Subject Re - Mch. no. 2. 11. 28, Jewish Burial ground

NOTICE UNDER SCHEDULE VI CHAPTER XI, RULE 2 (1) OF
THE CITY OF KARACHI MUNICIPAL ACT, 1933.

PLAN SHOWING PROPOSED SHED WITH CHOWKIDARS QRT
& A DEAD HOUSE
IN THE JEWISH BURIAL GROUND
ON PLOT NO. K.28
TRANS LYAREE QUARTER
SCALE 8 FT. = 1 INCH

PLAN NO. 261 OF 1934

DETAIL OF R.C. BEAM AT "H"
SCALE 4 FT. = 1 INCH.

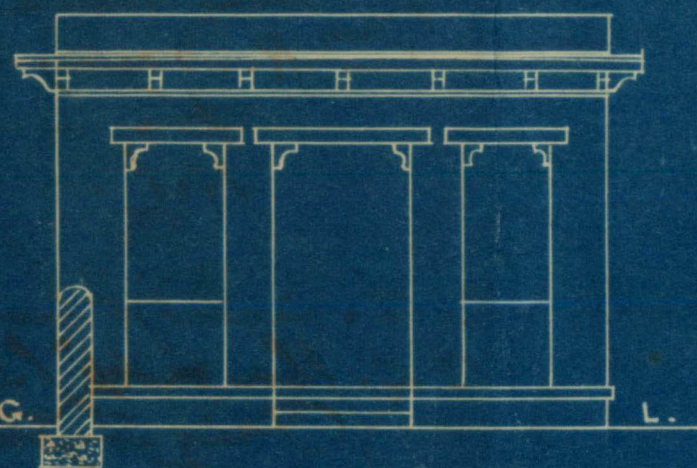
1. Communicate L.S. objection of the 6th. in R.
and also say that 12"x8" for 20' span
will be do.

1. The land shown ~~yellow~~ *X on file plan* is not yet granted to the institution and hence plans cannot be approved.
2. 12' x 20' ~~span~~ *span* will not do.

14' x 20' 5' 1" provide.

SITE PLAN
SCALE 80 FT. = 1 INCH.

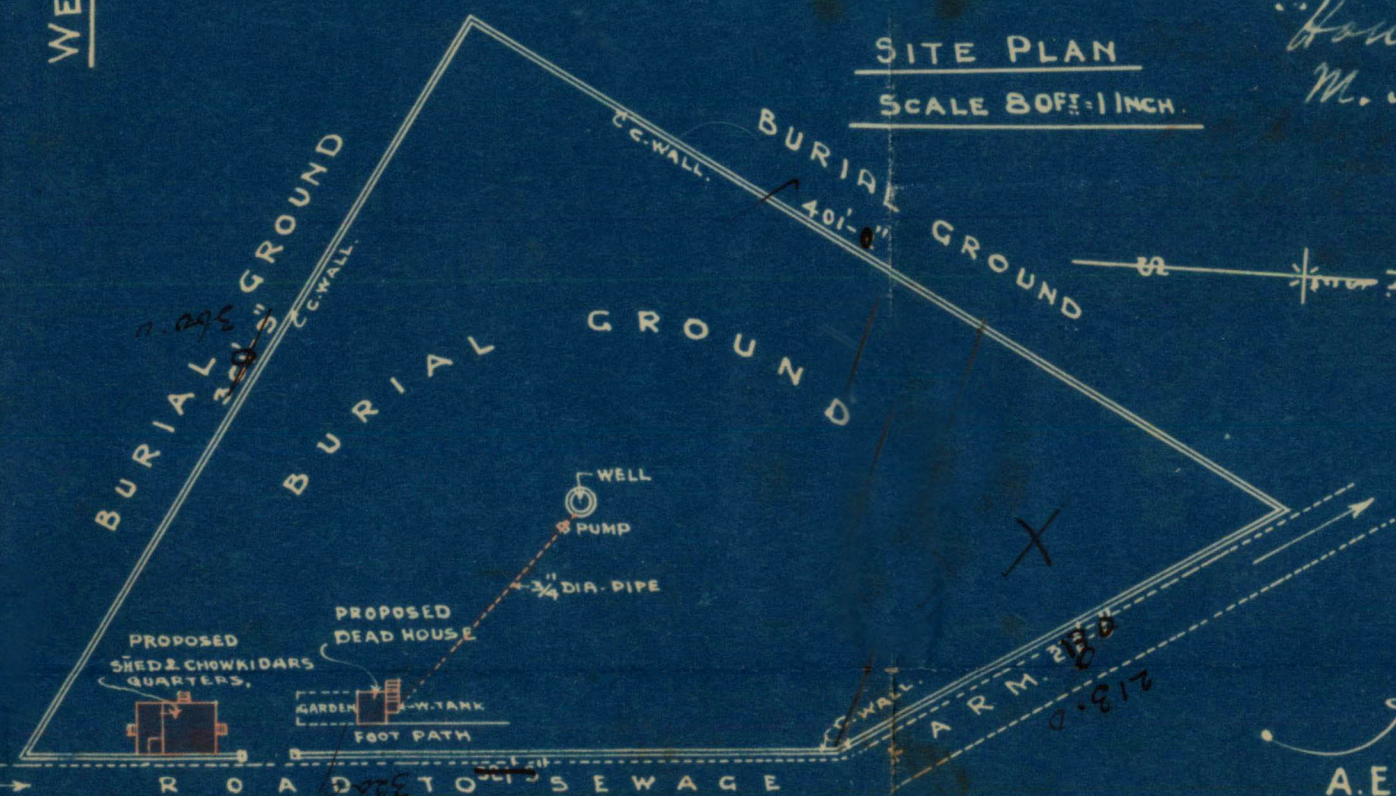
Remarks Land to be granted is also marked as above

(1) All the side measurements require corrections to be made.

(2) There is ^{an} ~~not~~ lay out of the portion under reference.

Authority of the portion granted must be produced.

Please see the
attached plan. The
land shown yellow
is not yet granted
and must be
shown

KARACHI MUNICIPALITY
PART PLAN OF SHEET NO. 28
LYARREE QUARTER
SCALE 1:2500

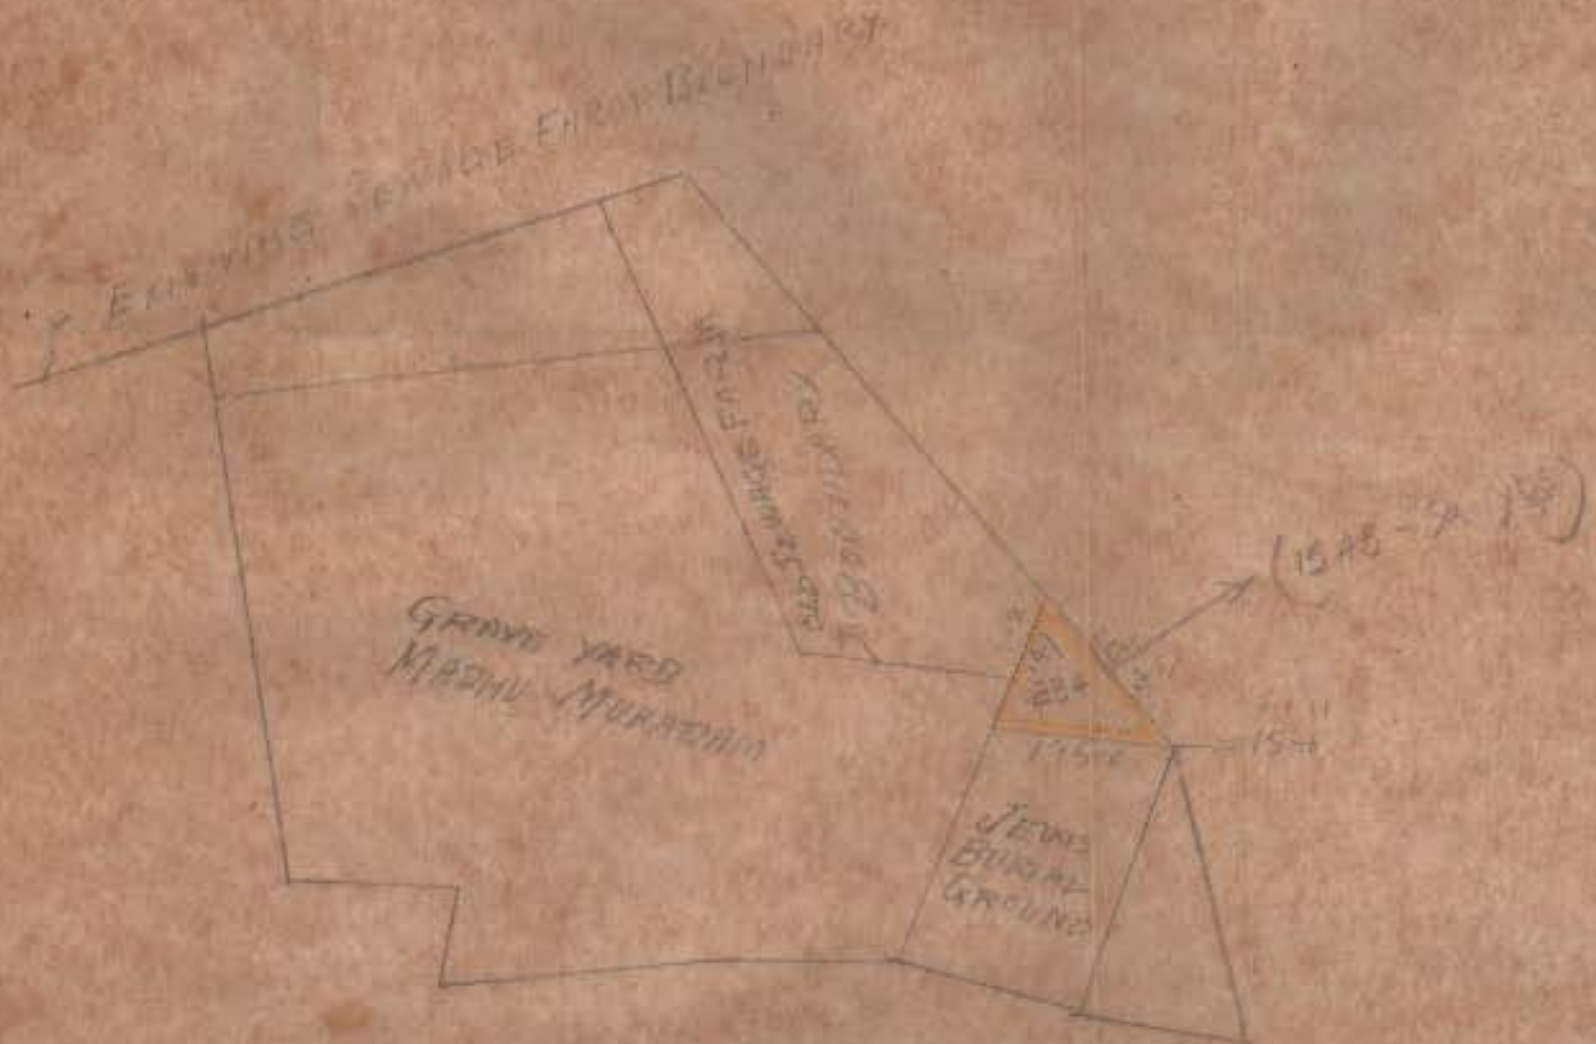
H. W.
Please attach
copies of original
plan of the alignment
if granted

W. S.
21/5/34
The required plan
is attached
herewith.

No objection. The original plan of grant is herewith
W. H. H.
5/8/34
